Access Compliance Report Public Rights-of-Way (Curb Ramps)

Main Street: MAIN_ST Cross Street: 1ST_ST Location: NE

ADA ID: RPRK211026173249 Ramp Type: Type 4 - Parallel Initial Pass/Fail: Pass Overall Compliance: No Severity Score: 25

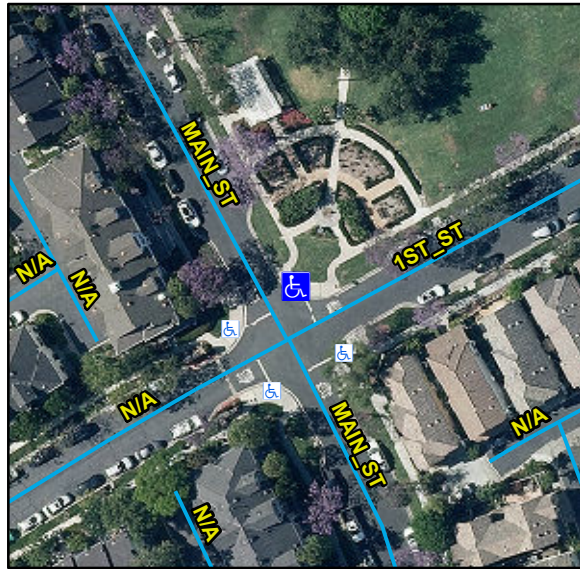
Compliance	Description	Data	Compliance	Description	Data
N/A	Ramp Length LT (in)	99	N/A	Ramp Length RT (in)	104
Yes	Ramp Width LT (in)	89	Yes	Ramp Width RT (in)	88
Yes	Ramp Run Slope LT (%)	7.7	Yes	Ramp Run Slope RT (%)	4.6
Yes	Ramp Cross Slope LT (%)	0.2	Yes	Ramp Cross Slope RT (%)	1.9
N/A	Landing Present	No	No	DWS Provided	No
N/A	Landing Length (in)	N/A	N/A	DWS Contrast	N/A
No	Landing Width (in)	N/A	N/A	DWS Length (in)	N/A
No	Landing Run Slope (%)	N/A	N/A	DWS Full Width	N/A
No	Landing Cross Slope (%)	N/A		DWS Offset Type	N/A
N/A	Landing Movement Obstructed?	No	N/A	DWS Offset Left (in)	N/A
	Landing Movement Type	Curb	N/A	DWS Offset Right (in)	N/A
N/A	Landing Shared	N/A			
N/A	Clear Space	Yes			
N/A	Clear Space To Crosswalk (in)	48			
N/A	Marked Crosswalk 1	No	N/A	Marked Crosswalk 2	No
	Crossing 1 Direction	W		Crossing 2 Direction	S
	Marked Crosswalk 1 Width (in)	N/A		Marked Crosswalk 2 Width (in)	N/A
N/A	Ramp Inside Crosswalk 1	N/A	N/A	Ramp Inside Crosswalk 2	N/A

Crossing 1 Slope (%)	0.2		Crossing 2 Slope (%)	0
	Crossing 1 Cross Slope (%)	0.7		Crossing 2 Cross Slope (%)	2.2
Yes	Gutter Ponding	No	Yes	Curb Slope	1.9
Yes	Gutter Lip Height (in)	0		Road Run Slope (%)	1.8
No	Gutter Run Slope (%)	10.6		Road Cross Slope (%)	0.9
Yes	Gutter Cross Slope (%)	2	No	Perpendicular Joint Present	No
Yes	Overall Surface Condition	Acceptable			
	Cross Gutter Present?	No		Spandrel Present?	No
	Replace Cross Gutter?	N/A		Replace Spandrel?	N/A

Remove & Replace Curb Ramp With Two New Directional Ramps or Equivalent. Remove & Replace Gutter.
